PRODUCT UPDATE BULLETIN

15-0004

PREVENT DAMAGE WHEN INSTALLING TRANSIT BULKHEADS

LOW ROOF PASSENGER'S SIDE

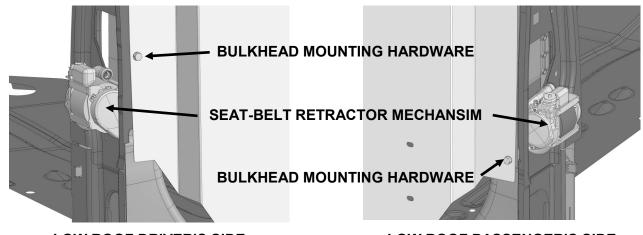
Weather Guard Transit implemented a change in January 2015 to Low-roof Bulkhead models 96301-3-01 and 96302-3-01 relocating the lowest mounting holes on the side panels to increase the clearance between seat belt retractor and the blind fasteners as shown in the figures below. The lowest mounting hole on the driver side mounting panel needs to be at least 4.0 inches above the bottom corner of the bulkhead panel. The lowest mounting hole on the passenger side mounting panel needs to be no more than 1.5 inches above the bottom corner of the bulkhead panel. Using these hole locations the mounting hardware and blind fasteners are above or below the retractor mechanism.

Check the hole location of low-roof Transit bulkheads. If they are not the same as current production, drill new lower mounting holes as shown on page 2 of this bulletin.
